Economic Commission for Europe**Inland Transport Committee****World Forum for Harmonization of Vehicle Regulations****Working Party on Lighting and Light-Signalling****Seventy-fifth session**

Simplification of lighting and light-signalling Regulations**Proposal for Supplement 12 to the original version of
Regulation No. 99 (Gas-discharge light sources)****Submitted by the Informal Working Group "Simplification of the
Lighting and Light-Signalling Regulations"***

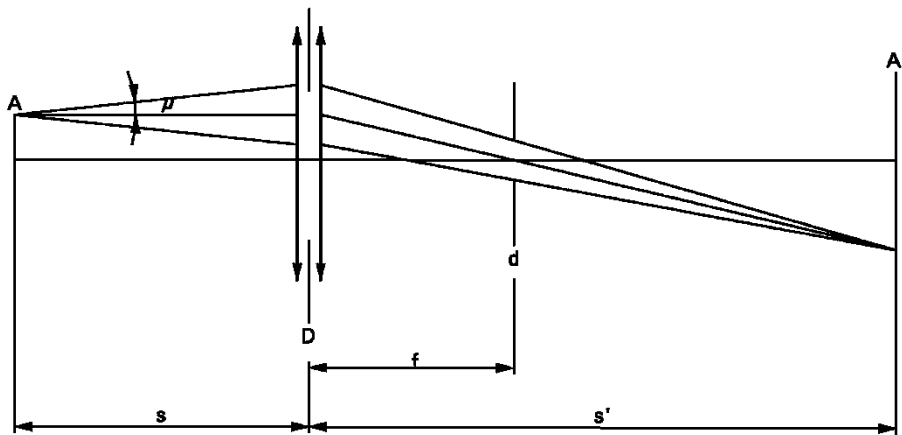
Paragraph 10., delete the figure and amend to read:

The colour of the light source shall be measured in an integrating sphere using a measuring system which shows the CIE chromaticity co-ordinates of the received light with a resolution of ± 0.002 . ~~The following figure shows the colour tolerance area for colour white and the restricted tolerance area for the gas discharge light sources D1R, D1S, D2R, D2S, D3R, D3S, D4R, D4S, D5S, D6S, D8R and D8S.~~"
